Planning Commission

Regular Meeting Agenda

Frances Meaders Council Chambers
151 Willowbend Road
January 26, 2026 | 6:30 PM

CONCEPT PLAN FOR
 BRADSHAW ESTATES

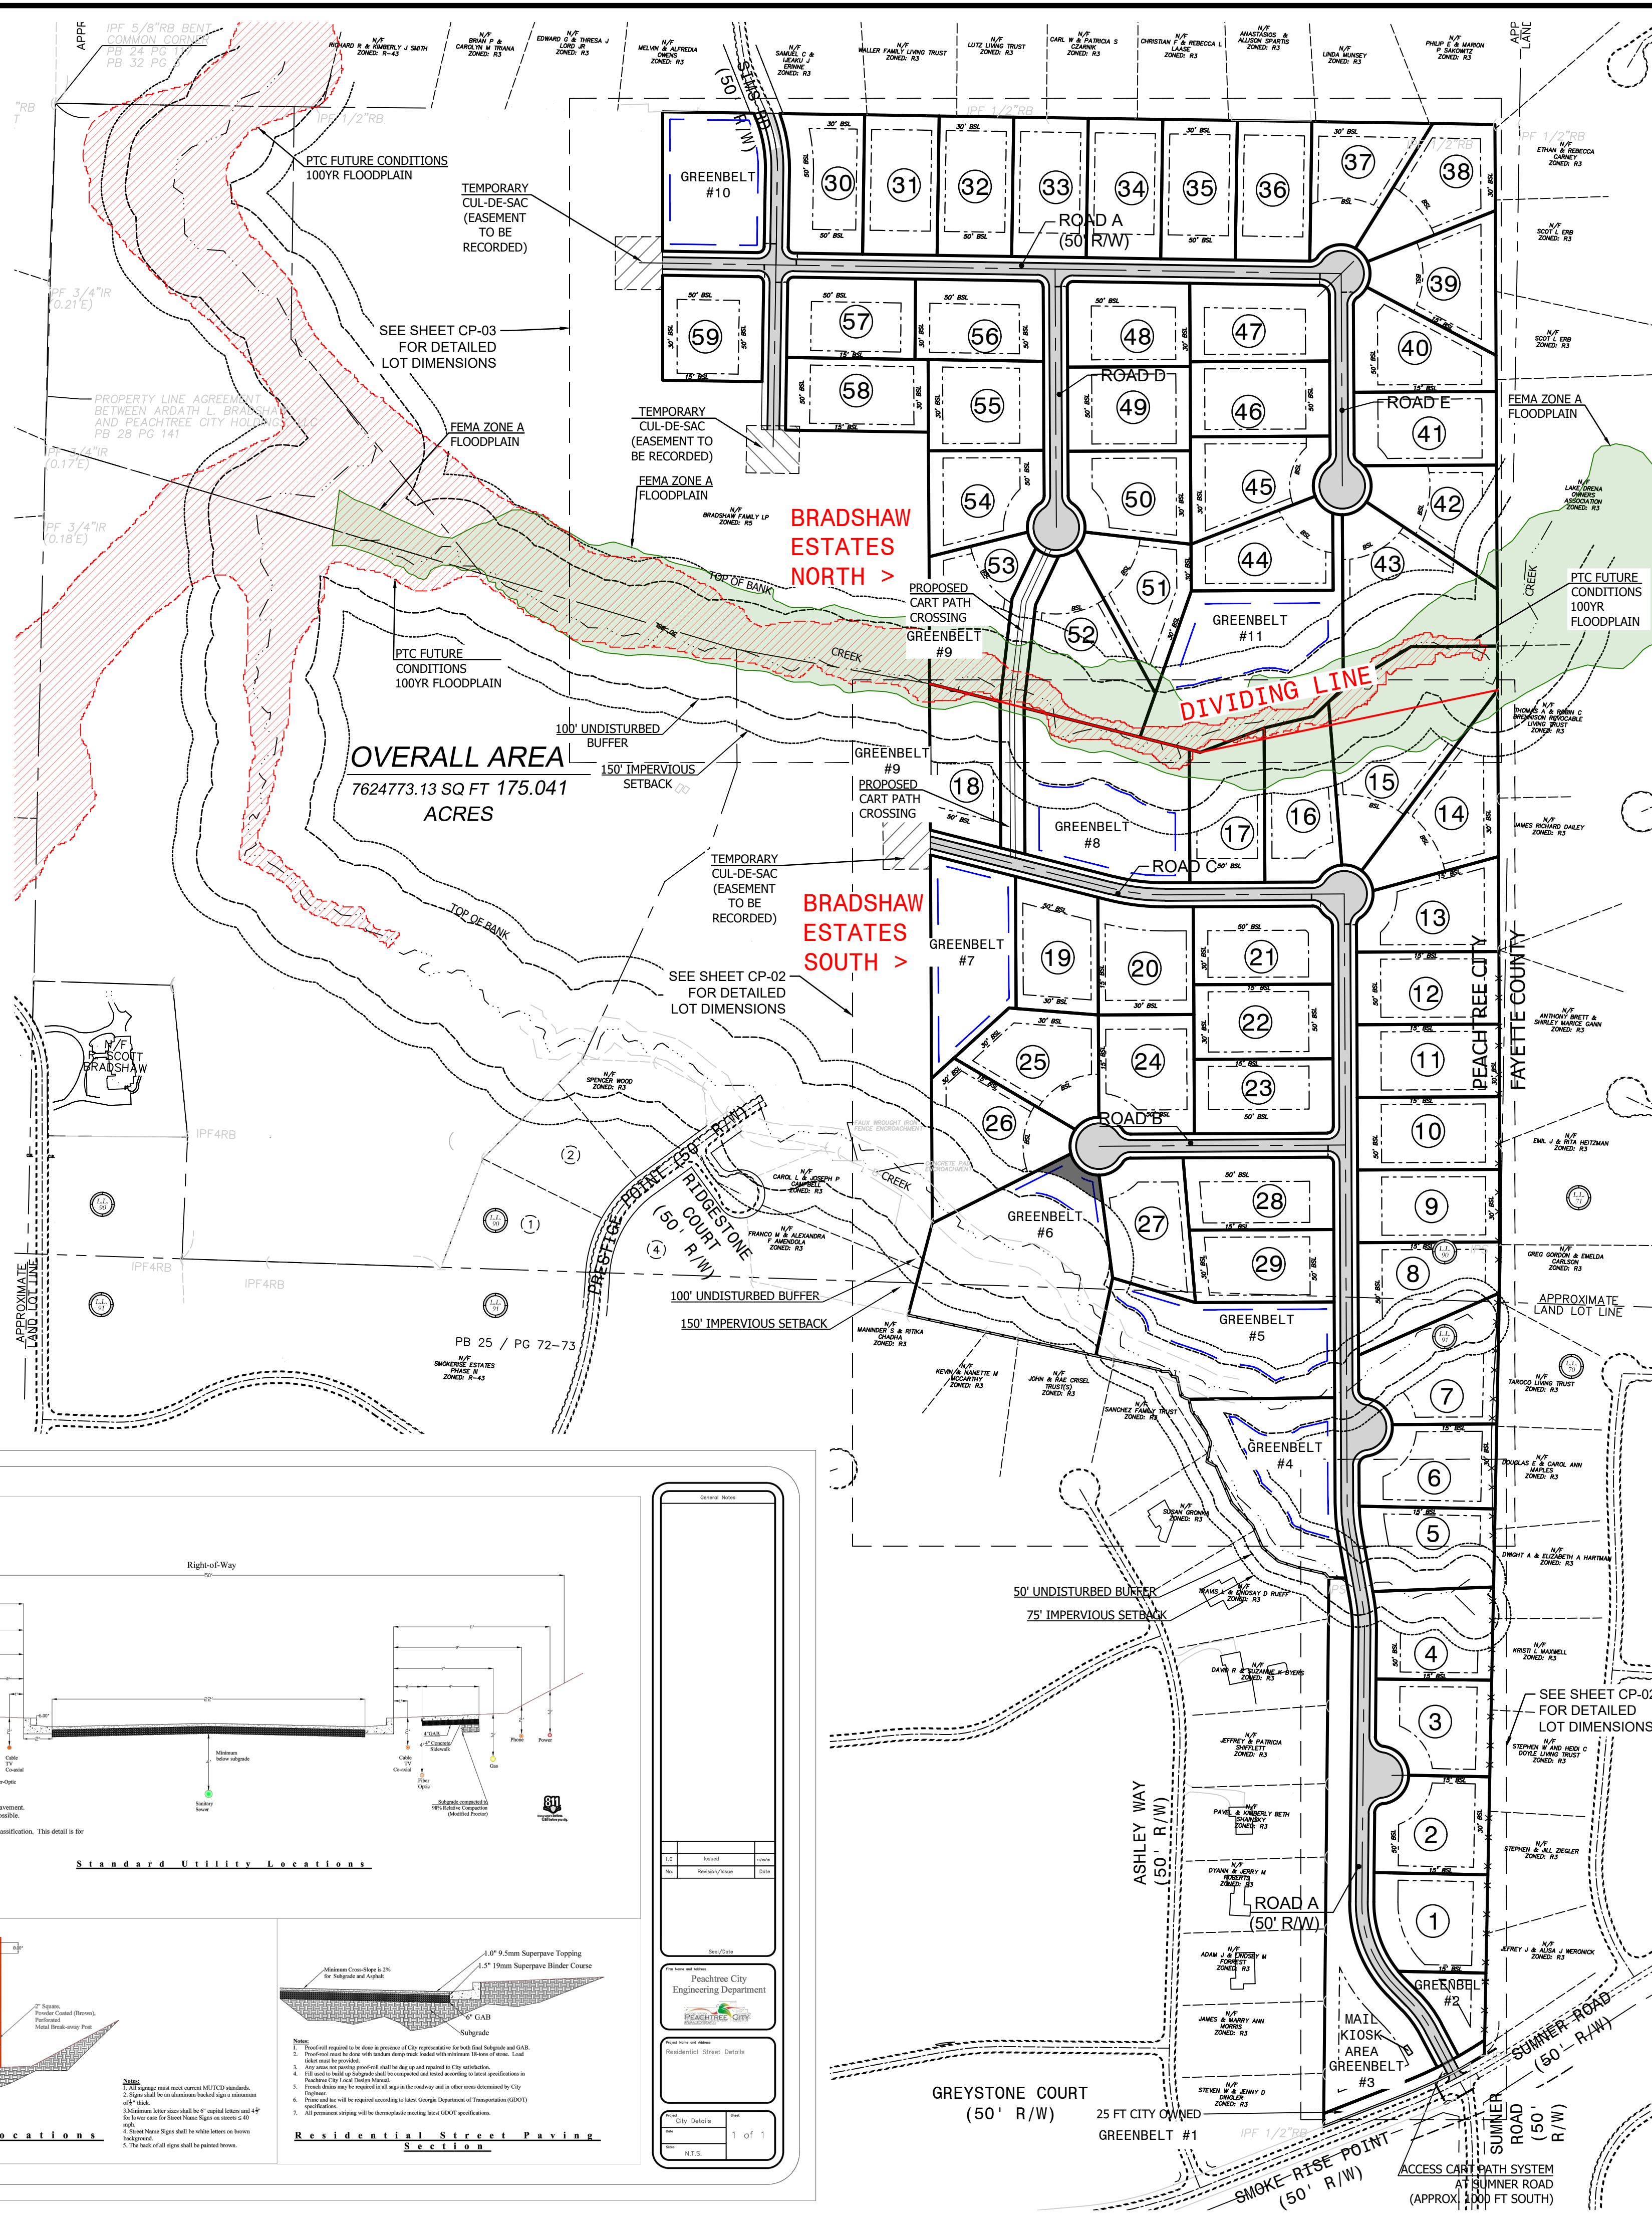
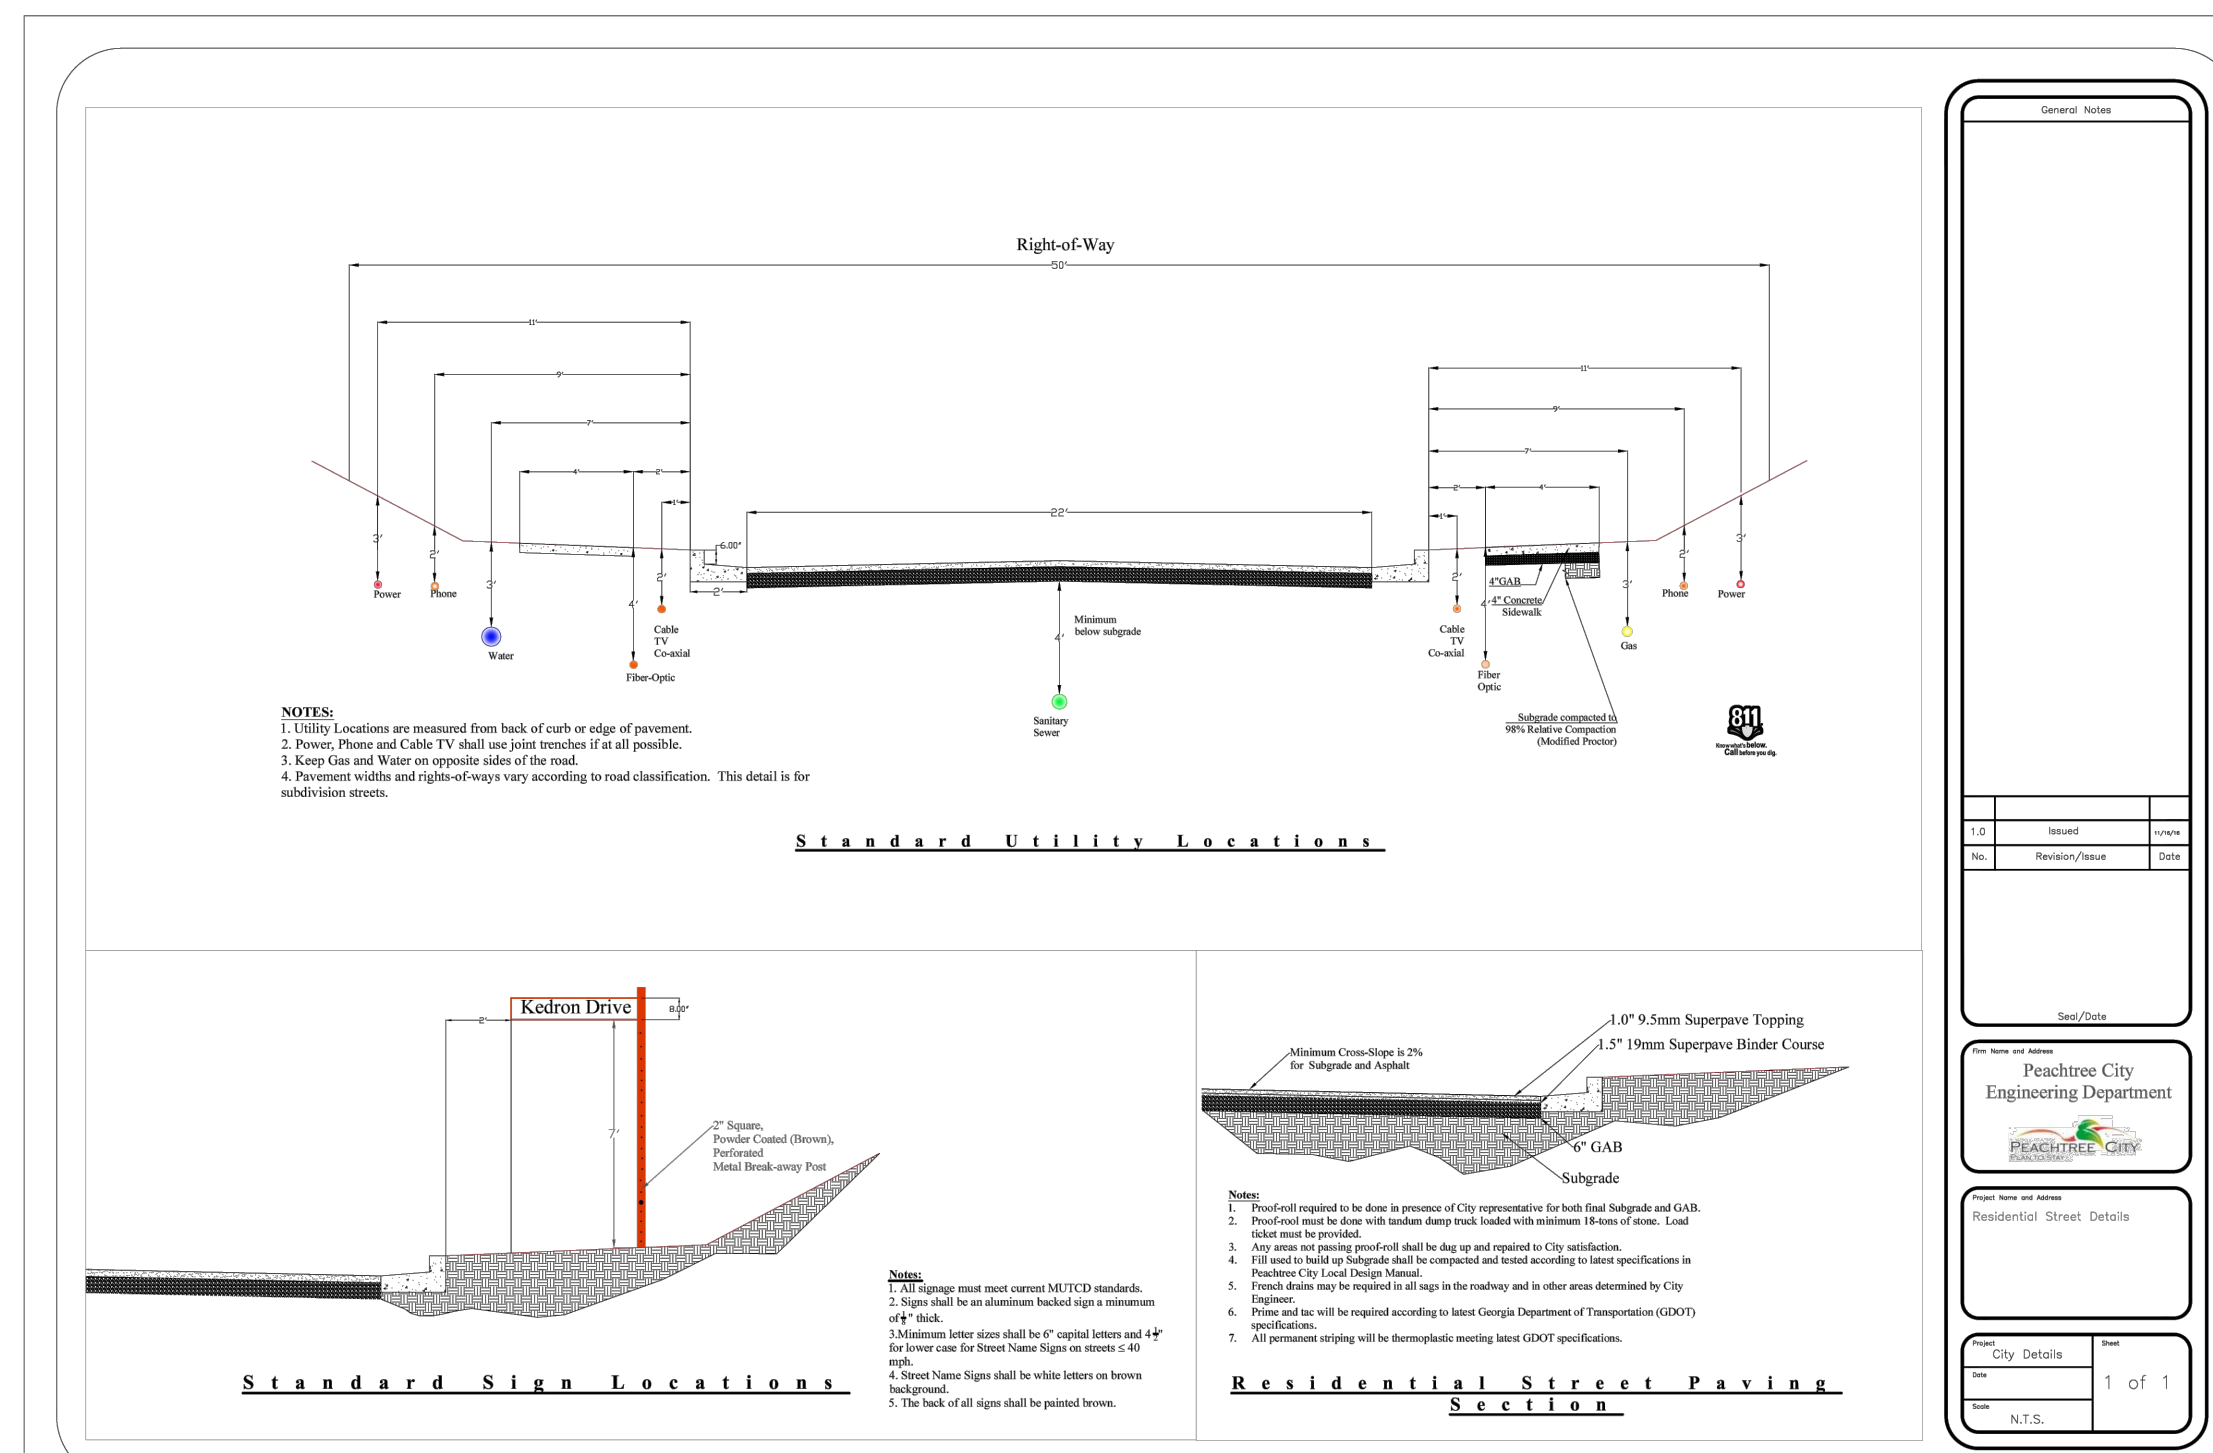
Staff has reviewed the concept plat and is of the opinion the plat meets the zoning ordinance and development standards. However, staff has some concerns regarding response times for public safety that will be increased with the proposed layout of the subdivision.

The Peachtree City Police Department has expressed concerns regarding the safety of residents due to the extended response times that will result from the absence of a roadway connection between the north and south portions of the proposed subdivision. Below is a comment provided by the Police Department:

- *The Police Department has concerns regarding the existing extended response times to the rear portion of Kedron Hills along Astoria Lane. The addition of roadway infrastructure and residential development in this area, as proposed in the northern section of the Bradshaw development, would further increase response times and expand the number of residents and locations potentially impacted by those delays. To help mitigate these concerns, the Police Department recommends the inclusion of a connecting roadway between the northern and southern parcels, with access to both Astoria Lane and Sumner Road.*
 - The Fire Department has raised similar concerns.

I am a resident of Peachtree City residing at **515 Ashley Way**, directly adjacent to the proposed subdivision on **Parcel 0720 001**. I am writing to express significant concerns regarding the current concept plan, specifically the layout of **Proposed Lots 1-5** and the **new internal road** located immediately behind the existing homes on Ashley Way.

The concept plan shows extensive clearing along the shared property line behind Ashley Way, including the removal of mature tree stands that currently function as:

This configuration would create **reverse-frontage lots** for the Ashley Way homeowners, which is exactly the condition Section 903 is intended to prevent.

- require the applicant to **revise the Concept Plan** to eliminate this reverse-frontage condition, **and**
- establish a **meaningful buffer and tree-save area** between any revised new street and the existing Ashley Way properties to mitigate the conflict with Section 903’s design principles.

“Based on the amount of impervious surface area” (**acreage?**), “including structures, drives, parking areas, and sidewalks”, the landscape ordinance requires a minimum “caliper inches of canopy trees and how many for each lost within the Platt’ **and** “caliper inches of understory trees” The concept Platt proposal is for 141 canopy inches and 94 understory inches, **(Doug Maples Comment)** **which means there is only less than 5 caliper inches per each of the lots.** No alternative compliance method is required since the total requirement will be planted on site. **(Doug Maples Comments will referenced further as (DM comments)** **In addition, is there a standard for landscape buffer for the homes on the east side or rear of the development to help shield the existing homes from noise, and screening?**

Section 1130(j) of the LDO states that "every Platted residential lot within the city shall plant and/or maintain no less than two trees at least two inches in diameter within the boundaries of the subject lot." **(DM comments)** The southern lots currently have a tremendous number of trees greater than fifteen inches in diameter. With the removal of numerous trees in this concept proposal the residential lots are only required to replace these numerous trees, with only five caliper inches of trees for each

STORMWATER MANAGEMENT (DM comments) The current condition of runoff from both sides of this Platt has maintained no impact on the runoff. However, the new impervious surfaces created by this development have the potential to have a negative impact. It is stated in the Platt General Notes the “project site are currently under investigation.” This indicates the need for protection impact by this Platt has NOT been established. So how can the concept Platt approval be provided without a defined protection plan being established?

In addition, the concept Platt does not indicate an erosion plan for the wetlands, flood prone areas, flood plain, and the creek on the north side of the 29 parcel Platt. Will this be addressed?

(g) The location of steep slopes, significant stands of trees, creeks, watercourses, stormwater detention and drainage ways, floodplains, wetlands, and any environmentally sensitive areas. **(DM comments) The concept Platt does not provide a clear indication on the locations of steep slope, significant stands of trees on each lot. The concept Platt does not indicate the tree and vegetation that will be protected along the drainage ways, floodplains, wetland and environmental sensitive areas.**

3. One (1) copy of a tree survey,.... **(DM comments) The concept Platt does not provide any tree survey count and trees required to be saved. This must be done to preserve to protect as many trees as possible for the reasons mentioned throughout the comments.**
